### Vertical Section

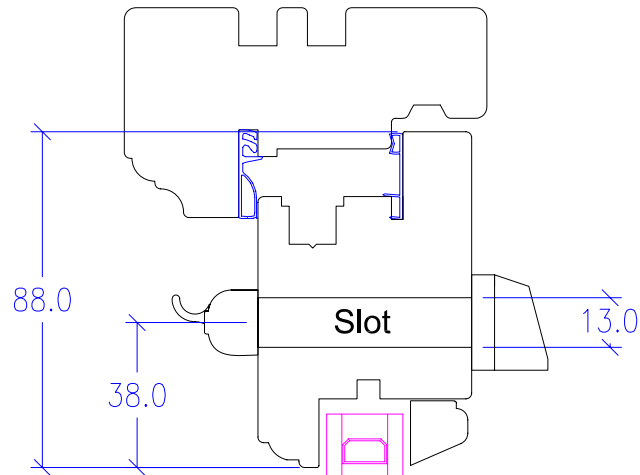
Sash top rail increased from 68mm to 88mm to accommodate Trickle Vent

Bottom Rail increased from 68mm to 88mm to match top rail

Standard Vent TTF Slimline 2500-13  
slot size 265x13

If Sash Glass sightline is under 320mm  
in width use TTF Slimline 1250-13  
Slot size 133 x 13
